**dsPIC33EVXXXGM00X/10X Family  
Silicon Errata and Data Sheet Clarification**

The dsPIC33EVXXXGM00X/10X family devices that you have received conform functionally to the current Device Data Sheet (DS70005144E), except for the anomalies described in this document.

FIGURE 1:

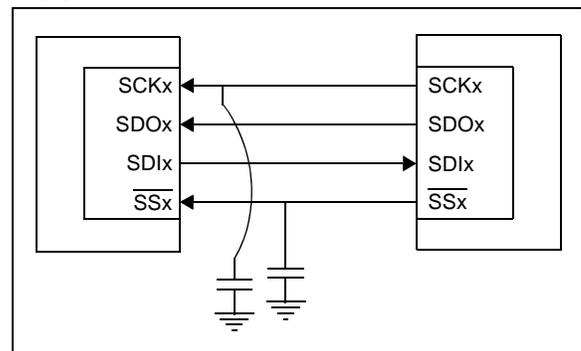
When the SPIx module is configured in SPIx Slave mode (MSTEN bit (`SPIxCON1<5>`) = 0), the frame slave (FRMEN bit (`SPIxCON2<15>`) = 1) and the SPIFSD bit (`SPIxCON2<14>` = 1), in Standard Buffer mode with the Clock Polarity Select bit, `CKP` = 0, the data is not transmitted in both 8-bit and 16-bit mode, but the data is being received correctly.

Adding a capacitance on the signal, as shown in [Figure 1](#), will help the data to be received properly.

**FIGURE 2: TIMING DIAGRAMS FOR CENTER-ALIGNED AND EDGE-ALIGNED MODES**

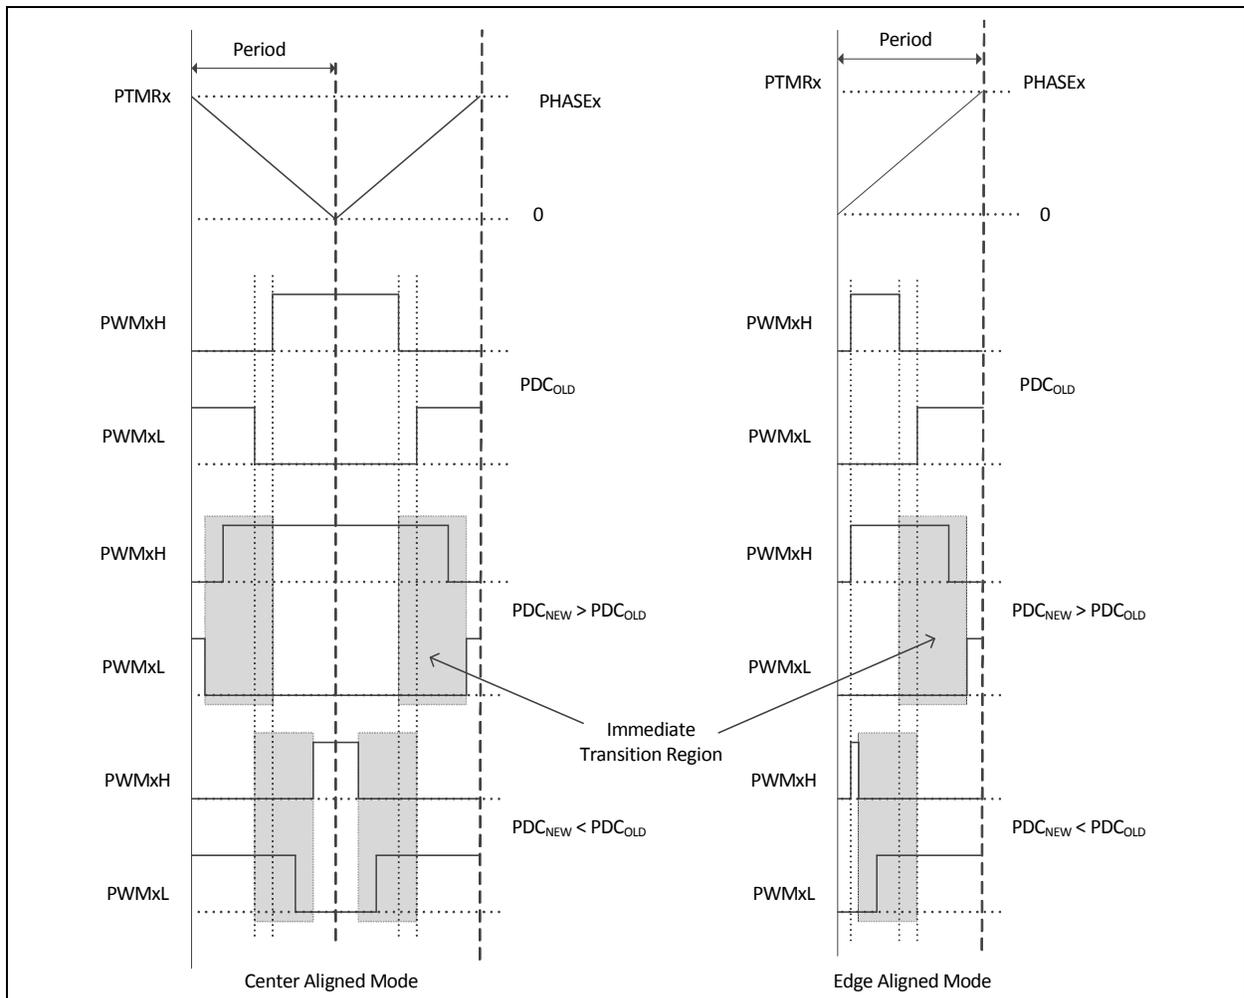
The PWM generator may not assert dead time on the edges of transitions. This has been observed when all of the following conditions are present:

In [Figure 2](#), if the duty cycle write occurred in the shaded box, then PWMxH and PWMxL will make an immediate transition without dead time.

However, in most applications, the duty cycle update timing can be controlled using the TRIGx trigger or Special Event Trigger, such that the above mentioned conditions are avoided altogether.

**FIGURE 3: ILLUSTRATION OF 1 TOSC GLITCH WHEN PWM OVERRIDE IS TURNED OFF**

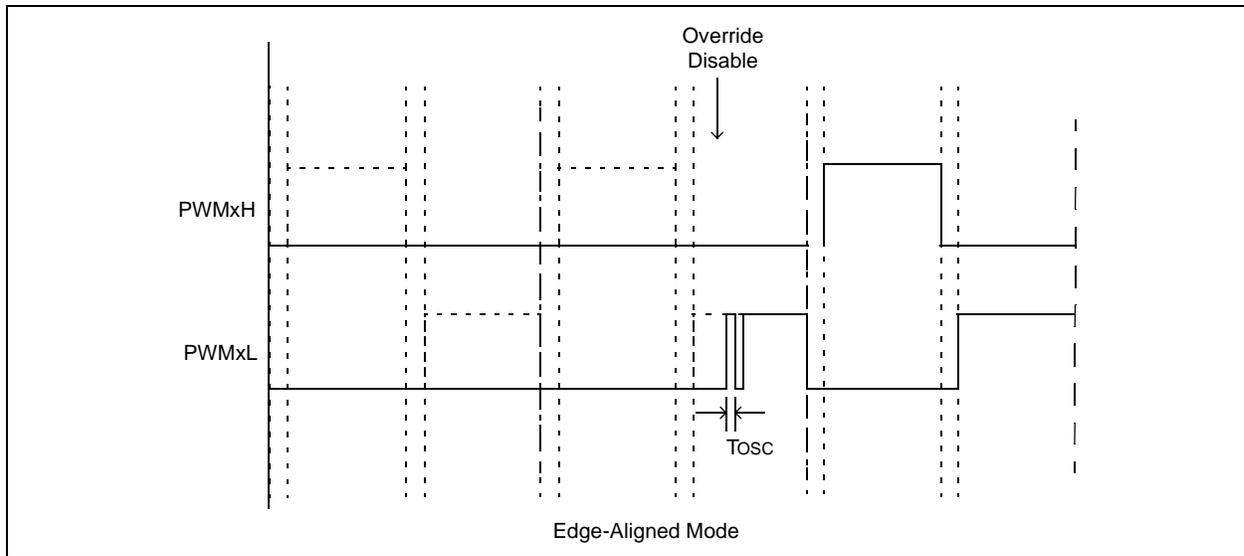
In Complementary mode after the PWM module is enabled (PTEN = 1), if the PWM override is turned off, a 1 TOSC glitch will be present on the rising edge of either the PWMxH or PWMxL pins, whichever occurs first, as shown in Figure 3.

The glitch will be present on PWMxH/PWMxL every time the override state is changed from override enabled to override disabled. The width of this glitch is equal to 1 TOSC when PCLKDIV<2:0> (PTCON2<2:0>) = 000. Increasing the PWMx input clock prescaler setting will increase the width of the glitch accordingly.

FIGURE 4:

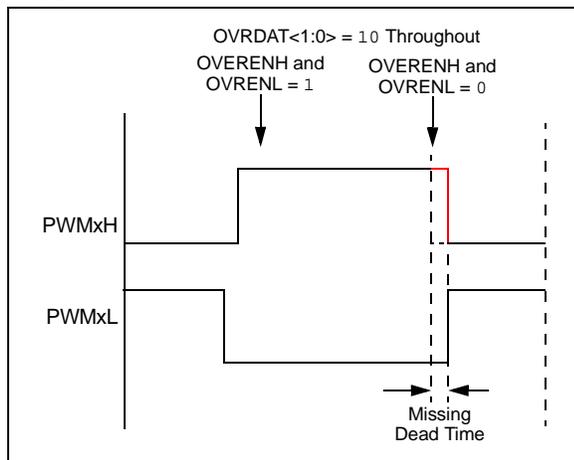
In Complementary Output mode, the expected dead time between transitions of the PWMxH and PWMxL outputs may not be asserted when the following occurs:

- Output override synchronization is configured to occur on the CPU clock boundary (IOCONx<0> = 0);
- Both PWMxH and PWMxL overrides are enabled prior to the event (OVRENH and OVRENL are both '1'), and
- Both overrides are disabled (OVRENH and OVRENL are both '0') at the instant the dead time should be asserted (Figure 4). This has been observed in both Center-Aligned and Edge-Aligned modes.

FIGURE 5:

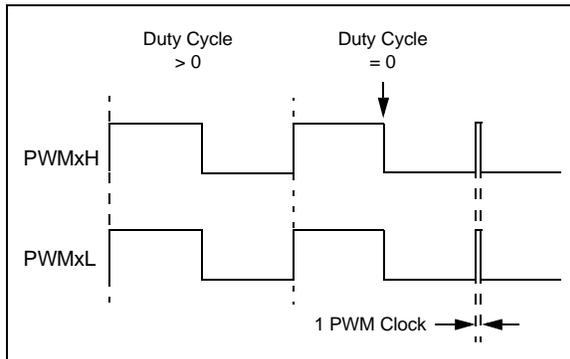
In the Redundant Output mode (IOCONx<11:10> = 10) and Push-Pull Output mode (IOCONx<11:10> = 01) with Immediate Update disabled (PWMCONx<0> = 0), when the Duty Cycle register is updated from a non-zero value to zero, a glitch pulse of a width equal to 1 PWM clock will appear at the next PWM period boundary, as shown in Figure 5, for the Redundant Output mode. Here, the Duty Cycle register refers to the PDCx register if PWMCONx<8> = 0 or the MDC register if PWMCONx<8> = 1.

1. Use the PWM override feature to override the PWM output to a low state instead of writing to the Duty Cycle register. In order to switch back to a non-zero duty cycle output, turn off the PWM override. The override-on and override-off events must be timed close to the PWM period boundary if the IOCONx register has been configured with IOCON<0> = 0 (i.e., output overrides via the OVDDAT<1:0> bits occur on the next CPU clock boundary).

2. Enable the Immediate Update (PWMCONx<0> = 1) while configuring the PWM module, i.e., before enabling the PWM module (PTCON<15> = 1). With Immediate Update enabled, writes to the Duty Cycle register can have an immediate effect on the PWM output. Hence, duty cycle write operations must be timed close to the PWM period boundary in order to avoid distortions in the PWM output.

**FIGURE 6:**

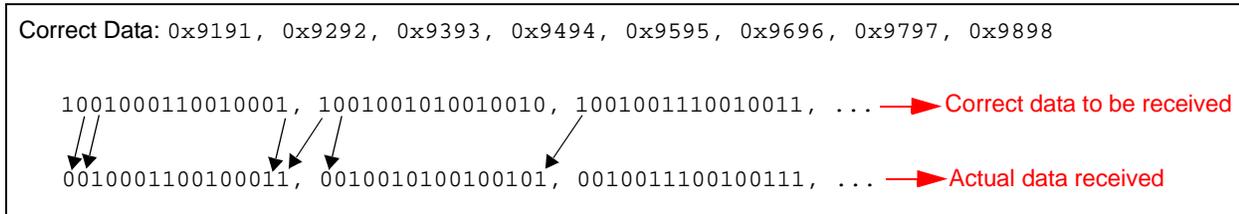
Received data of the SPI is sampled one clock cycle late for the following conditions:

For example, the correct data that should be received is 0x9191, 0x9292, 0x9393, 0x9494, 0x9595, 0x9696, 0x9797, 0x9898, but the actual data received is 0x2323, 0x2525, 0x2727, 0x2929, 0x2B2B, 0x2D2D, 0x2F2F, 0x3130 (Figure 6).
